## **Carnation Wastewater Treatment Facility**

# **FINAL ENVIRONMENTAL IMPACT STATEMENT**

October 2004

Figure 6-1

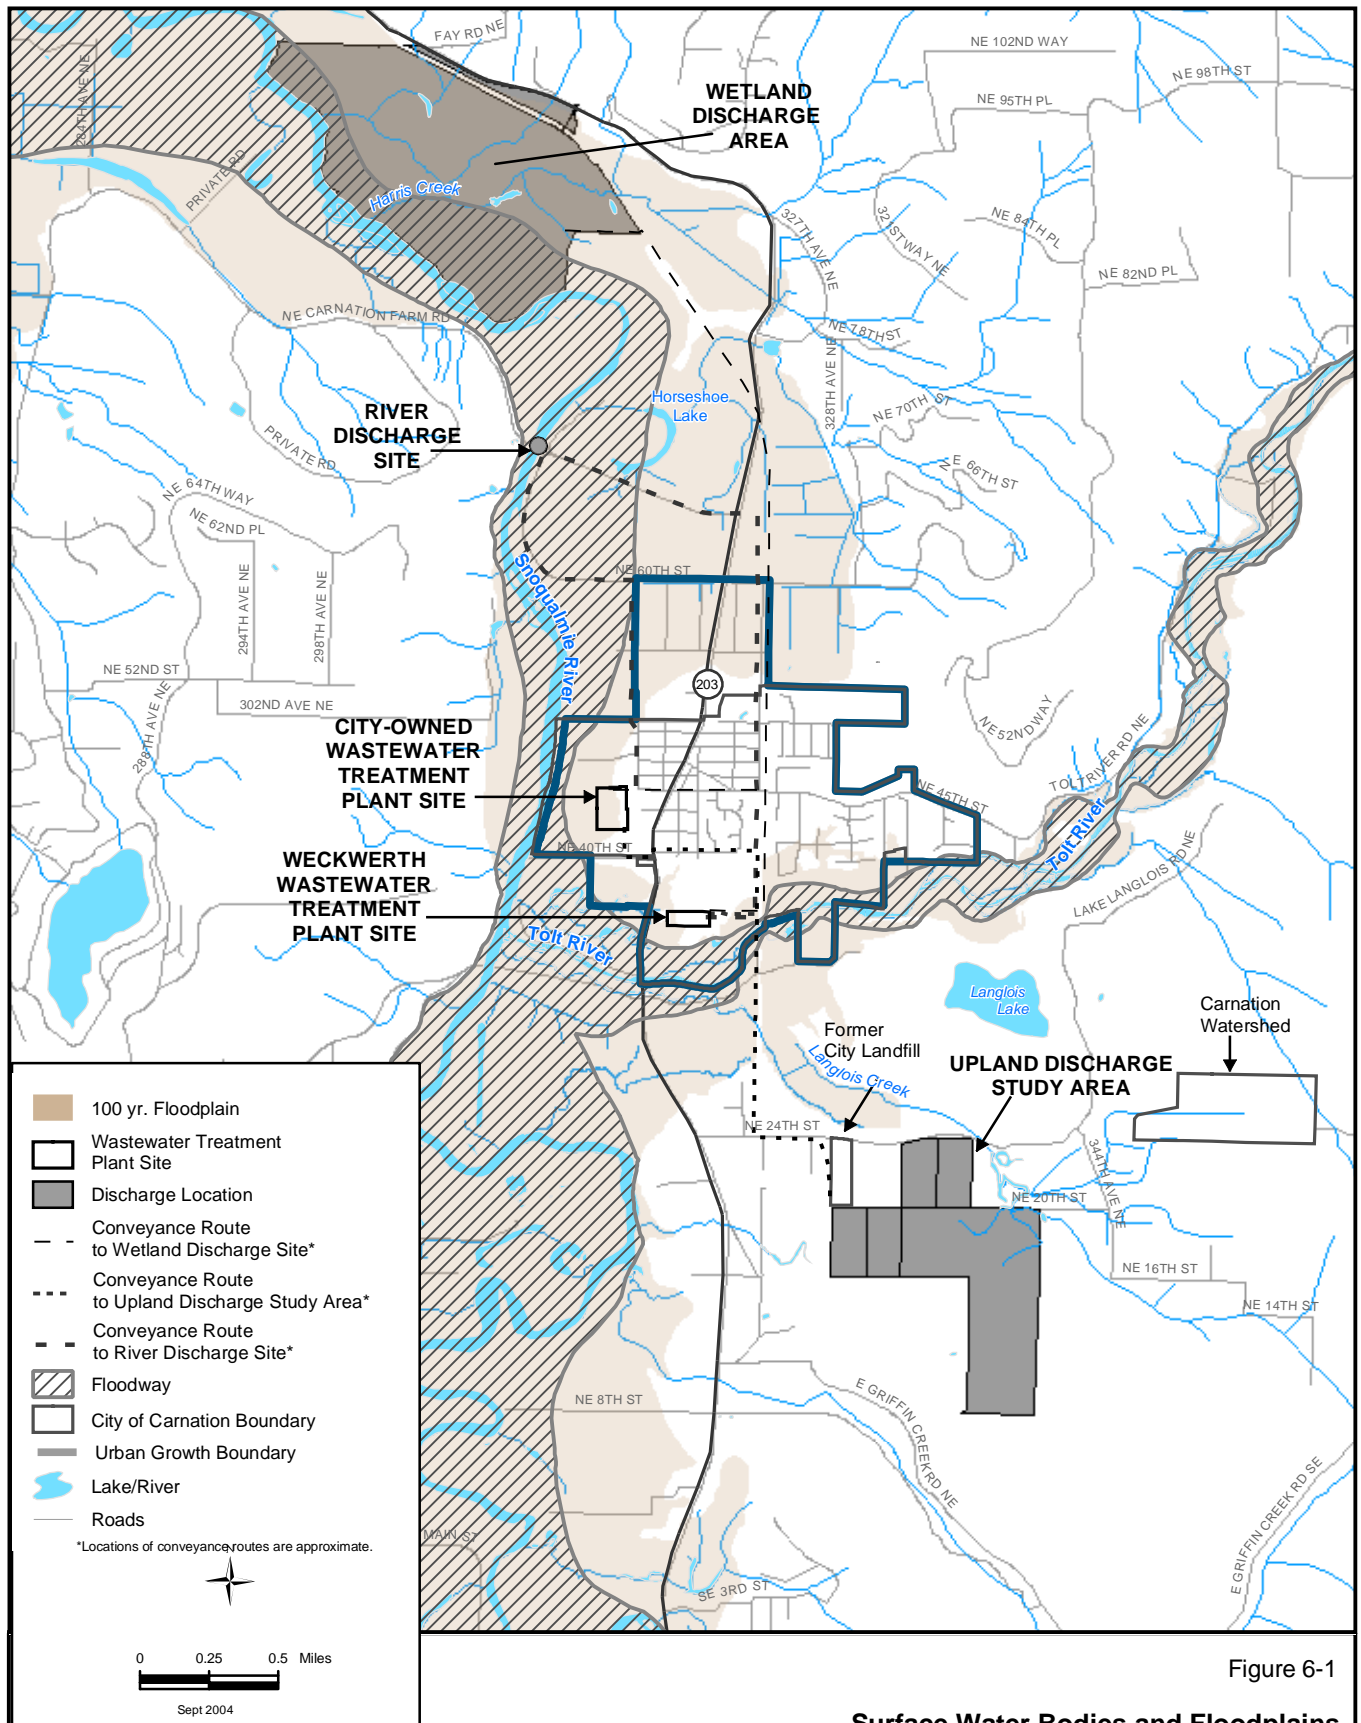
- The proposed "River Discharge Site" is located in King County's jurisdiction and within the FEMA Floodway and King County's Zero-rise Floodway. The proposed construction of outfall and installation of the conveyance piping will be required to meet the requirements of King County's Flood Hazard Code. The installation of this conveyance piping shall not change the existing topography in the regulatory 100 year Floodplain.

As was disclosed in the Draft EIS, a portion of each Wastewater Treatment Plant site is within the 100-year floodplain. The decision makers, the King County Executive in coordination with the Carnation City Council, will consider the impacts disclosed in the Draft and Final EIS when selecting a site for the treatment plant. Please see the response to comment Washington State Department of Natural Resources, S2-2 for further discussion of alternative selection. The final decision on where the facility will be located will be made through the consideration of policy criteria and environmental factors. Any portion of the wastewater treatment facility located in the 100-year floodplain would be designed to meet applicable federal, state, and local flood proofing and development standards.
